2. **Resolution No. 411. Delta Logistics Site Expansion.** The applicant is requesting approval of a Stage 1 Preliminary Plan, Stage 2 Final Plan, Site Design Review, Waivers, Class 3 Sign Permit, Type C Tree Removal Plan, Standard SROZ Map Verification, Standard SRIR Review and Variance for Development of a 58,116 square foot warehouse / manufacturing building with accessory office space at 9710 SW Day Road, and minor site modifications at 9835 SW Commerce Circle.

**DEVELOPMENT REVIEW BOARD  
RESOLUTION NO. 411**

Exhibit A1  
Staff Report  
Wilsonville Planning Division  
Delta Logistics Site Expansion

<b>Hearing Date:</b>	May 8, 2023
<b>Date of Report:</b>	May 1, 2023
<b>Application No.:</b>	DB22-0007 Delta Logistics Site Expansion
<b>Request/Summary:</b>	The requests before the Development Review Board include a Stage 1 Preliminary Plan, Stage 2 Final Plan, Site Design Review, Waivers, Class 3 Sign Permit, Type C Tree Removal Plan, Standard SROZ Map Verification, Standard SRIR Review, and Variance.
<b>Location:</b>	9710 SW Day Road and 9835 SW Commerce Circle. The property is specifically known as Tax Lots 600 and 601, Section 2B, and Tax Lot 400, Section 2CA, Township 3 Sout

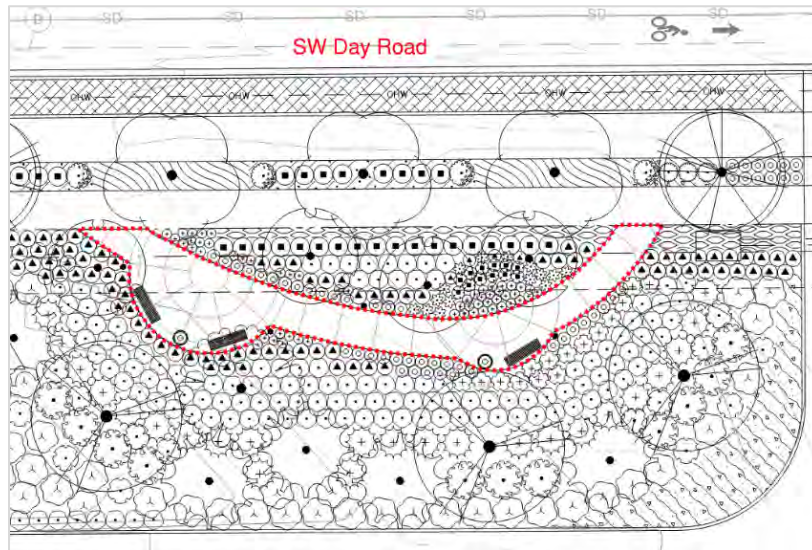
**B43.** As shown in the illustration, below, the proposed wayside is exclusive of the required landscape screening and has at least one minimum dimension of 20 feet along the looping path on its southwest, south, and southeast sides. Perimeter landscaping does not obscure visual access to the wayside from the SW Day Road right-of-way; dense landscaping behind the wayside, on its south side, visually separates it from the outdoor semi-tractor trailer parking/storage interior to the site.

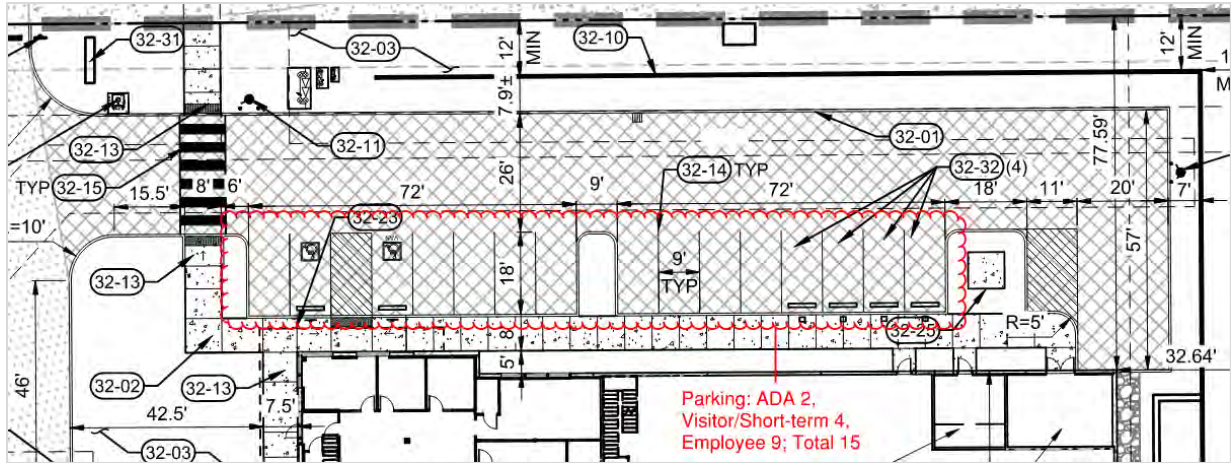
**D1.** The applicant requests to waive the vehicle parking area design standards from the Coffee Creek Design Overlay District. Subsection 4.134 (.11), Table CC-3, 4. Parking Location and Extent/Addressing Streets allows 16 spaces maximum with an adjustment to 20 spaces on an Addressing Street. This parking is limited to one double-loaded bay to be designated for short-term (1 hour or less), visitor, and disabled parking only between the right-of-way of the Addressing Street and building. This standard is listed as one of three in Section 4.134(.08) Waivers that shall not be waived unless there is substantial evidence in the whole record to support a finding that the intent and purpose of the standard will be met in alternative ways.

The applicant proposes 15 vehicle parking spaces on the north side of the building between the building and Addressing Street SW Day Road, which is less than the maximum of 16 spaces. However, the applicant proposes to designate nine (9) of the 15 spaces for employees, which is not permitted by the standard, thus requiring a waiver.

Waiver 2: Grading and Retaining Walls Height on Addressing Street

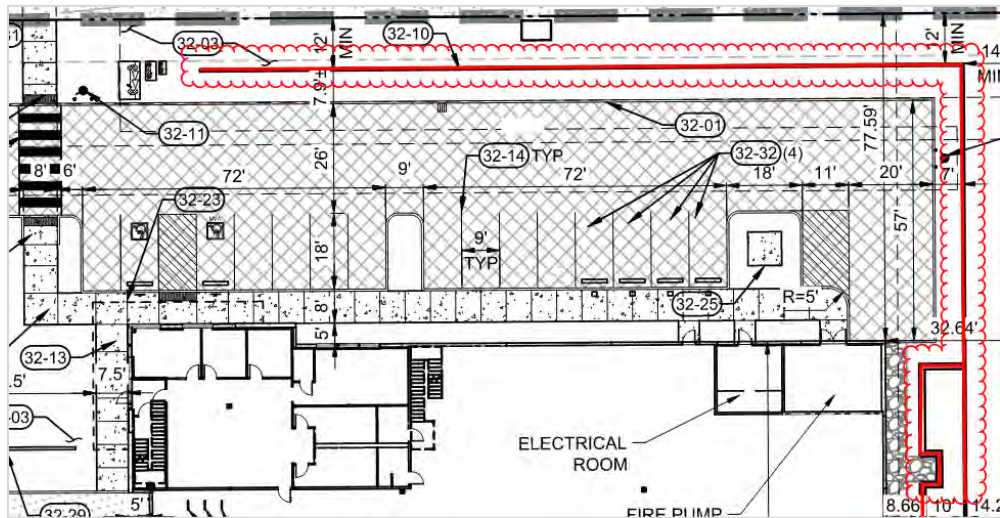
**D3.** The applicant requests to waive the maximum retaining wall height standard from the Coffee Creek Design Overlay District. Subsection 4.134 (.11), Table CC-3, 5. Grading and Retaining Walls/Maximum Height/Addressing Streets requires landscape retaining walls to be a maximum of 48 inches tall; there is an allowed adjustment of 20% to 57.6 inches.

Building Sign Area Allowed  
Subsection 4.156.08 (.02) B. 1.

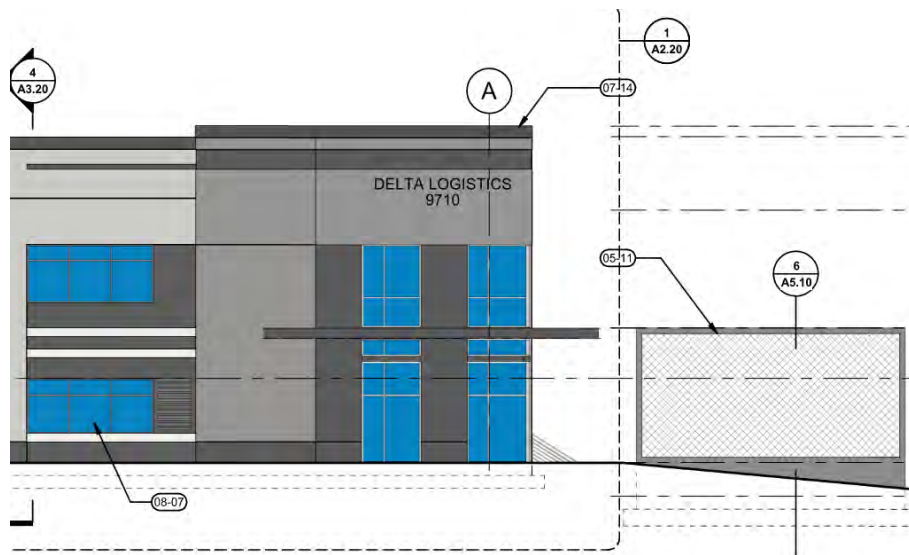
**E19.** The north façade of the proposed building is roughly 180 feet (ft) in length. For facades greater than 72 linear ft, the allowed sign area is 36 square feet (sf) plus 12 sf for each 24 linear feet or portion thereof greater than 72 ft up to a maximum of 200 sf. Therefore, the allowed sign area is 36 sf plus 60 sf ( $180 \text{ ft} - 72 \text{ ft} = 108 \text{ ft} / 24 \text{ ft} = 4.5 \text{ ft}$  (rounded to 5 ft);  $5 \text{ ft} \times 12 \text{ sf} = 60 \text{ sf}$ ), or a total of 96 sf. As the dimensions of the proposed wall sign are not shown on the applicant's plan sheets (Exhibit B2), a condition of approval has been added to ensure the sign area does not exceed the allowed area of 96 sf.

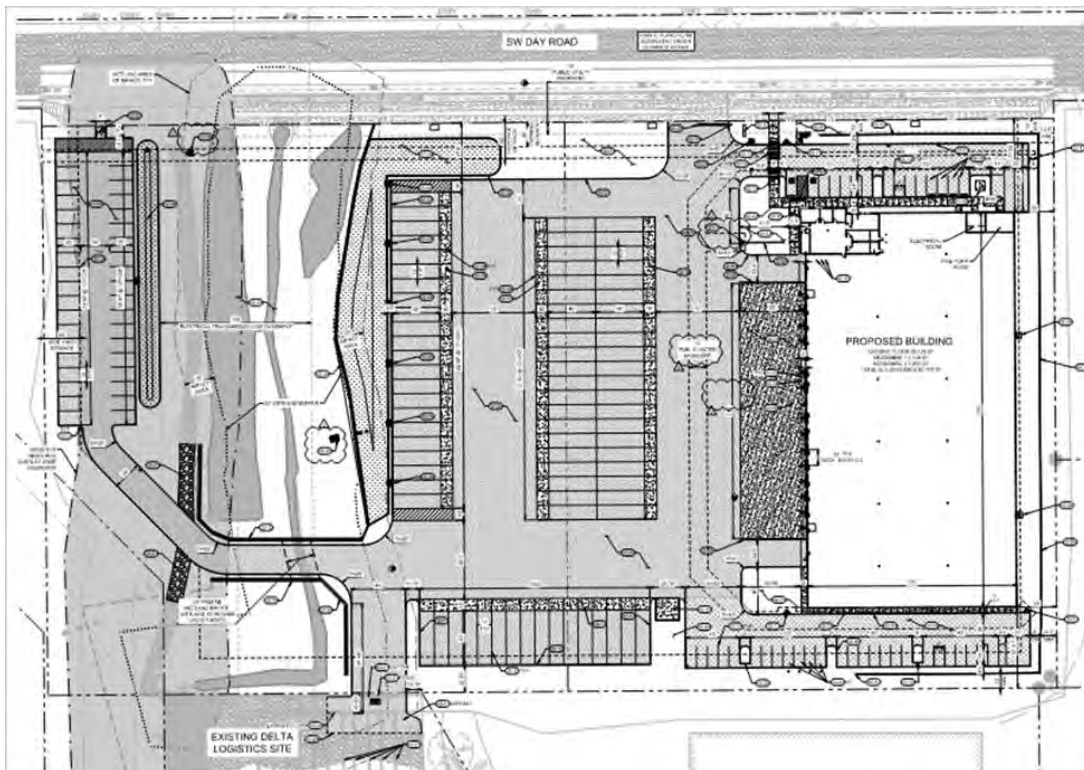
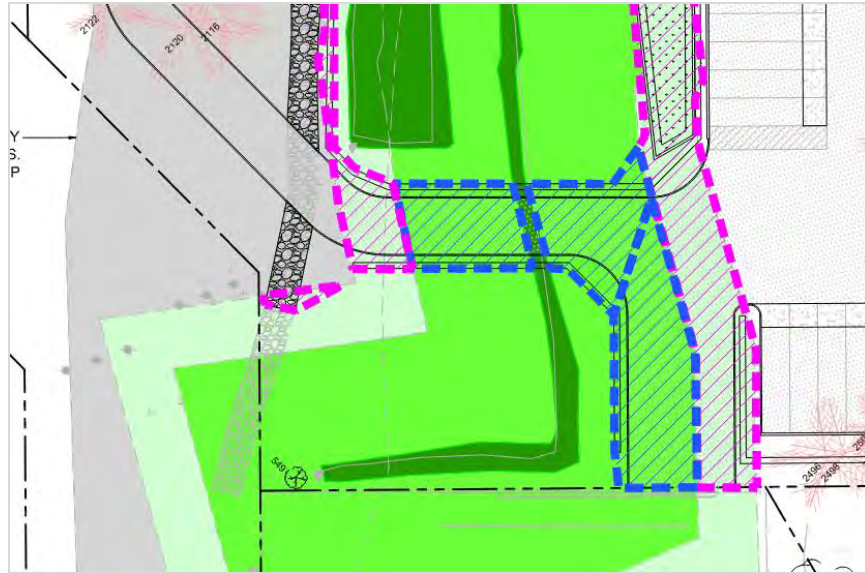
- I4.** As shown in the illustrations below, the applicant's preferred site design Option 1 proposes to cross the SROZ on the subject property with a drive aisle to enable access to the upland portion of the site, which contains approximately 0.95 acre, located west of the SROZ and its Impact Area. The upland area is proposed to accommodate a parking/storage area for trailer cabs used in the applicant's operations.
